Zoning Board of Appeals Meeting
Wednesday, May 29, 2019 at 7:30 pm
Sanford Hall
155 Village Street Medway, MA 02053
Meeting Minutes

39 Main Street Comprehensive Permit Application – (Continued from May 15, 2019) The Applicant SLV Medway, LLC seeks a Comprehensive Permit under MGL c. 40B, Sections 20 – 23 as amended, to allow construction of a 190-unit complex called “39 Main” in which 25% of the units (48 units total) will be affordable. The complex will be located on a 12.3-acre parcel in the Agricultural Residential I (AR-I) district of Medway, MA.

Ref: 39 Main Street
40B Site Plan Review
Tetra Tech Review

39 MAIN STREET
UTILITIES
PLAN OF LAND
IN
MEDWAY, MA

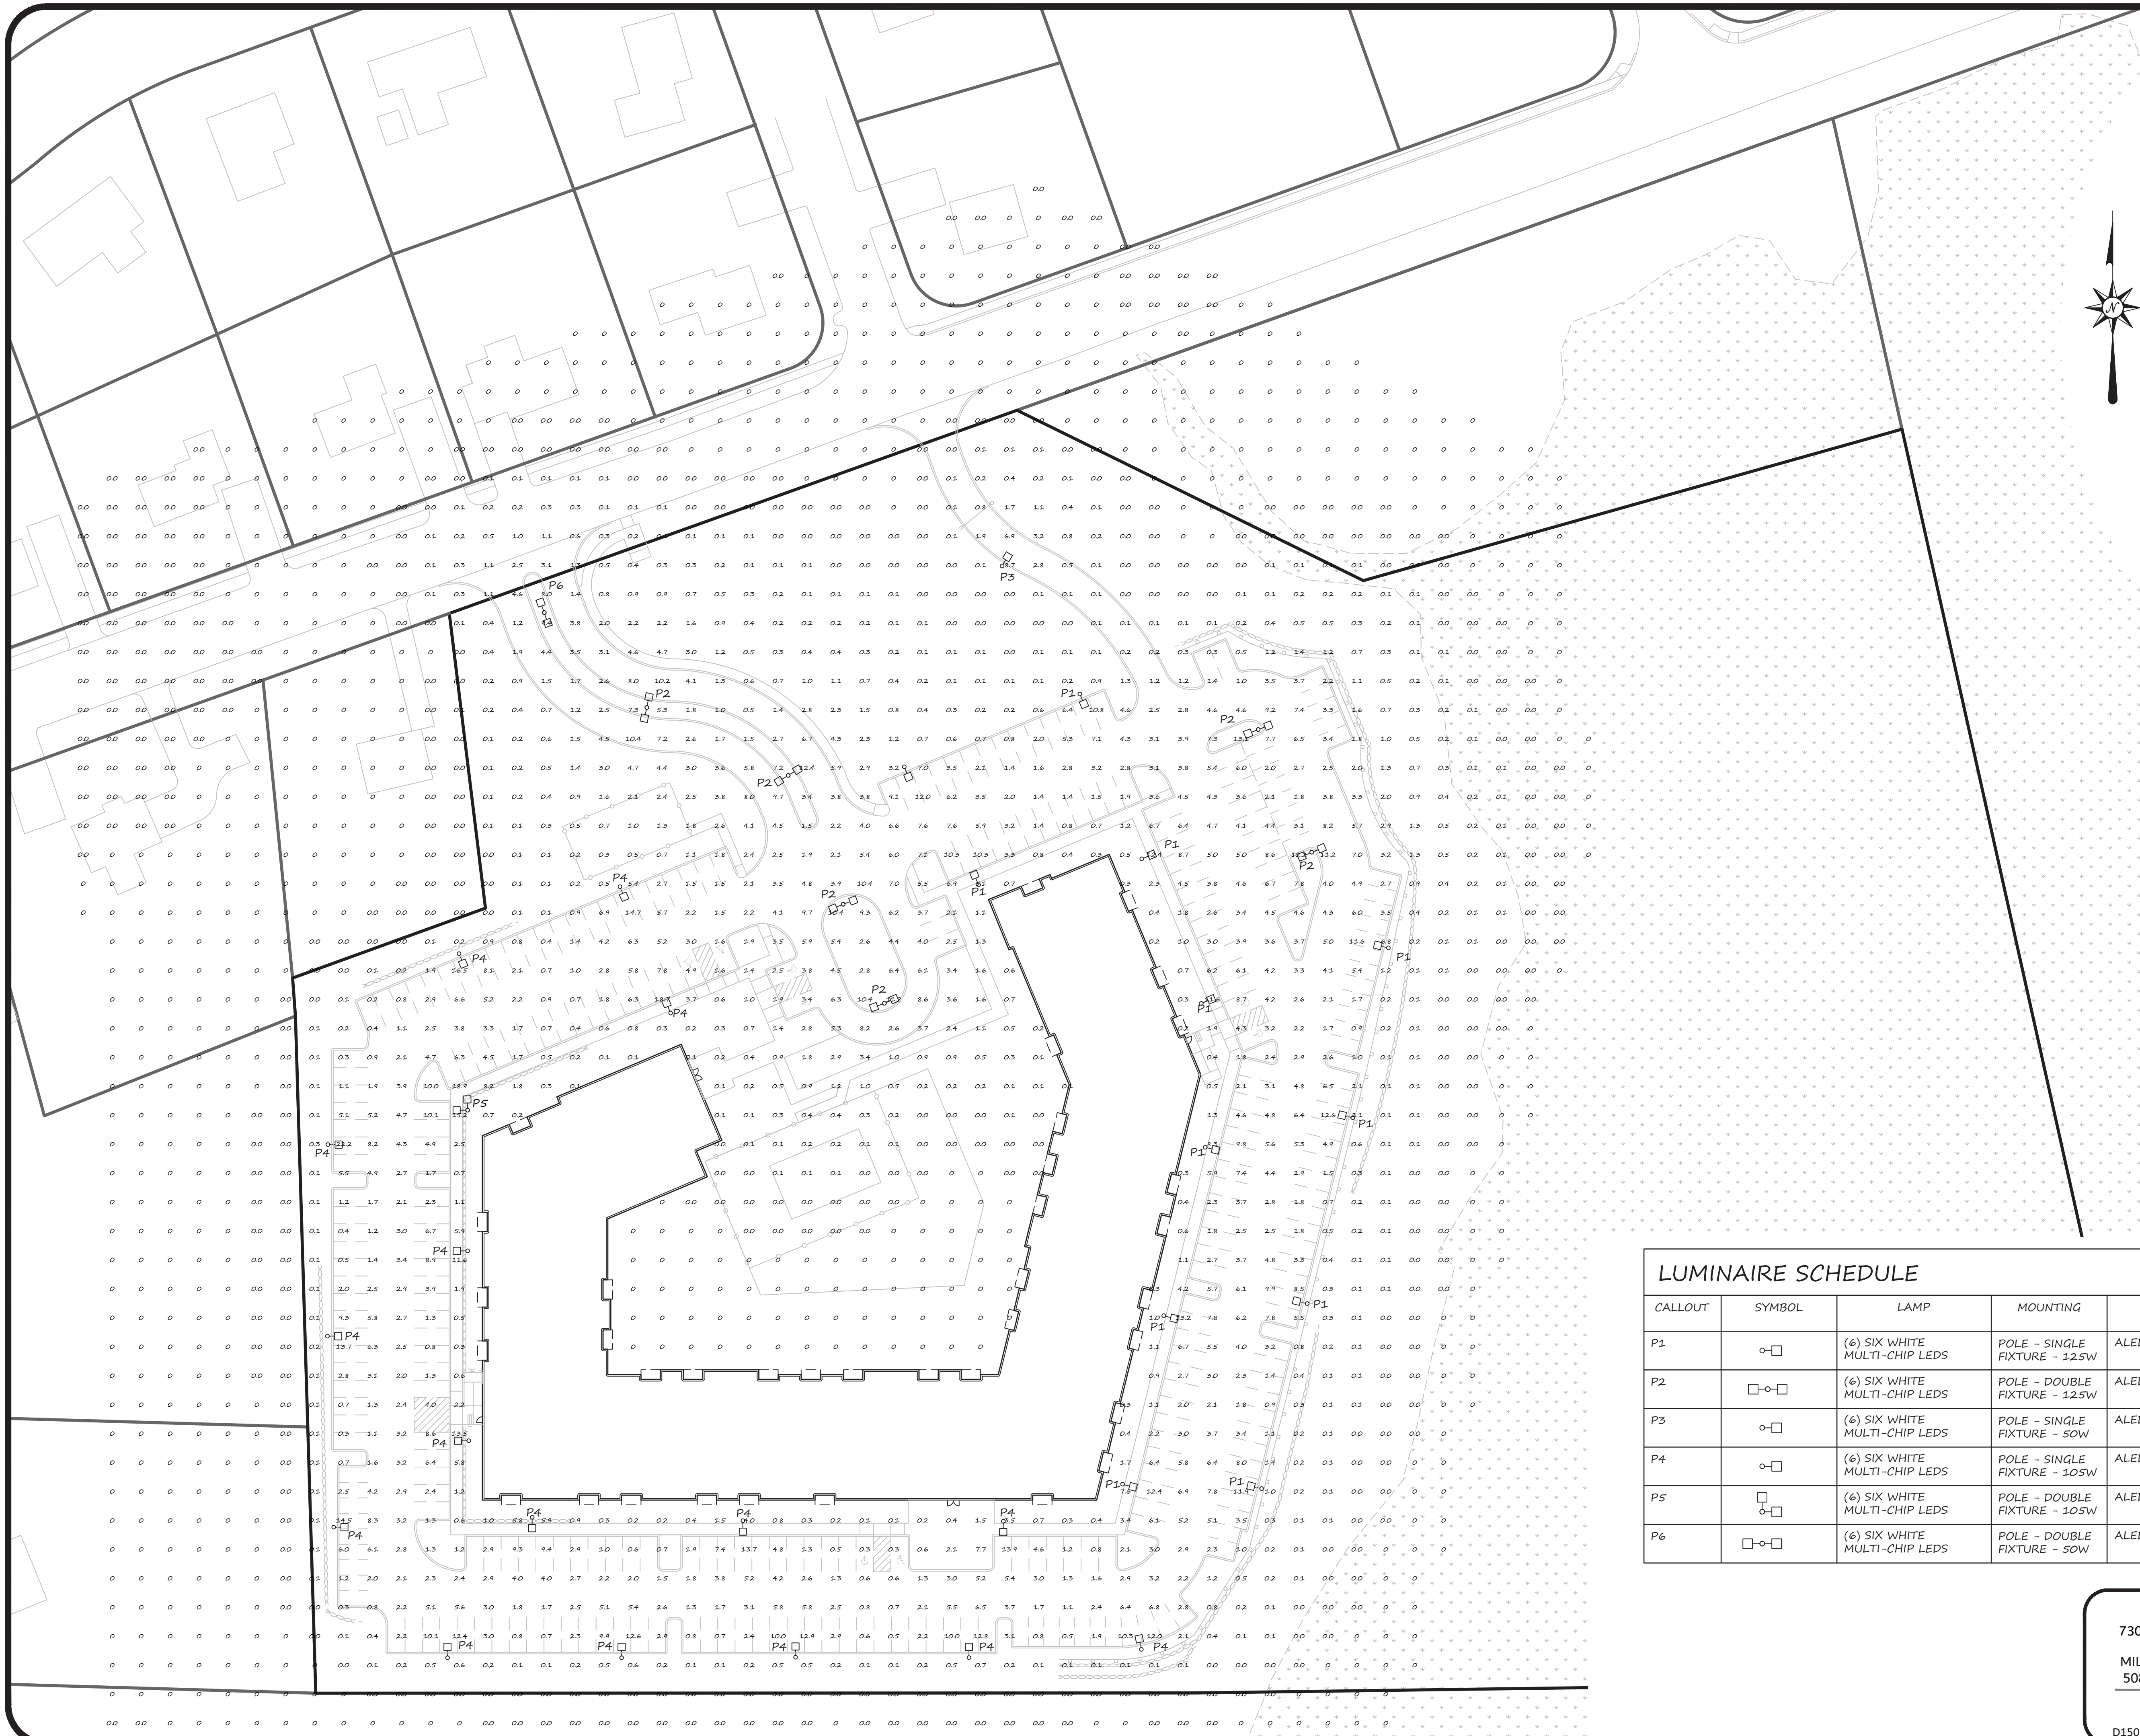
14. *Comment: An irrigation well has not been provided on the Plans. Municipal water supply shall not be utilized to irrigate the site.*

Response: The precise location and quantity of irrigation wells will not be determined until the construction phase when the site irrigation system is designed. However, two prospective well locations have been added to sheet C-8 along with Utility Note 3.
